ANN ARBOR HISTORIC DISTRICT COMMISSION

Staff Report

ADDRESS: 538 Fifth Street, Application HDC12-091

REPORT DATE: June 4, 2012

WEST ELEVATION Scale: 1/8" = 1'-0"

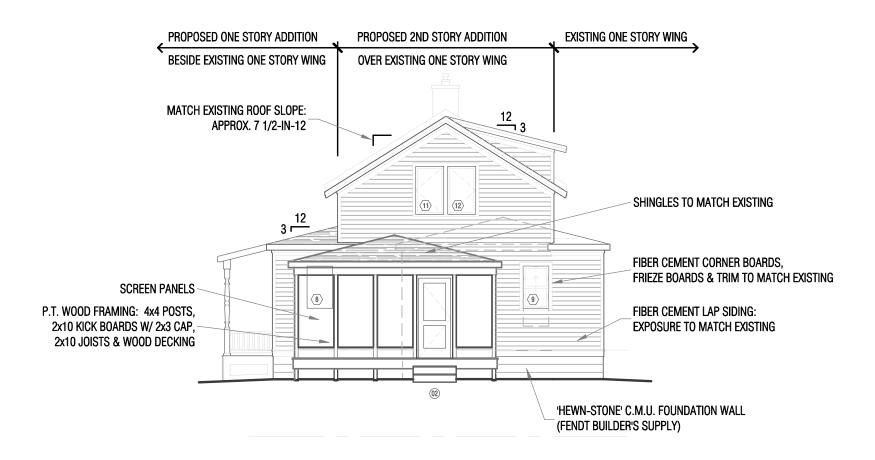
- 5. The applicant also seeks approval to construct a second-story addition above the existing rear addition to create a new bedroom. The proposed second-story addition would require removal of the roof structure and two windows in the second floor of the rear elevation. The roof line is lower than the existing roof on the main block of the house, and will not project beyond the existing north and south (side) elevations of the house. The second-floor addition will have a gable roof with asphalt shingles, fiber-cement siding and trim, and a shed dormer. The shed dormer will be located on the south (side) elevation and have two square, single-pane casement windows.

- 6. The applicant seeks approval to construct a new rear porch. The porch is sixteen feet eight inches wide, and thirteen feet six inches deep. It will be built of wood framing with large screen panels and will have a wood and screen door on the rear. The roof will be a hipped asphalt shingle roof.
